**Data Sheet Specification and
Design Change for Intersil
Product ZL9101MIRZ***

**Refer to:
PCN11118**

Date: November 16, 2011

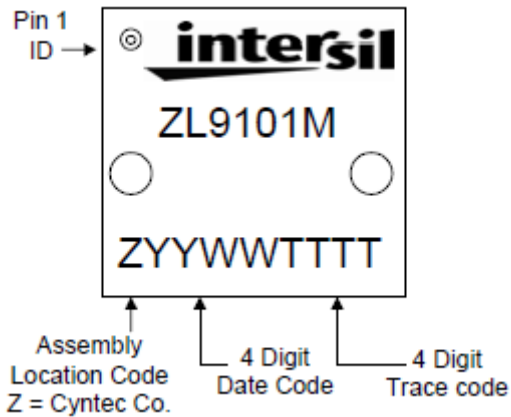
The data sheet electrical table limits and range changes are as follows:

Recommended Operation Conditions	Current Range	New Range
Output Voltage Range, VOUT	0.54V to 4V	0.54V to 3.6V
Output Current Range, IOU	0A to 15A	0A to 12A

Electrical Specifications - Parameter	Current Limit			New Limit			Unit
	Min	Typ	Max	Min	Typ	Max	
Input Bias Shutdown Current, IDDS	-	9.5	12	-	15.5	20	mA
Input Supply Current, IVIN	-	1.5	2	-	1.32	-	A
Driver Supply Current	-	190	220	-	190	250	uA
Output Load Current	Parameter Added			-	12	-	A
Switching Frequency Range	590	615	630	500	571	1000	kHz

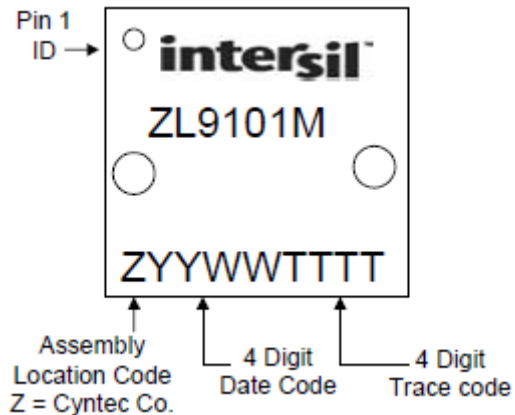
There will be no change in the part number marked on the packaged parts. Product manufactured with the improved design will begin with date code **1131** and use the new Intersil logo. Examples of the current and new branding/marketing layouts are included below.
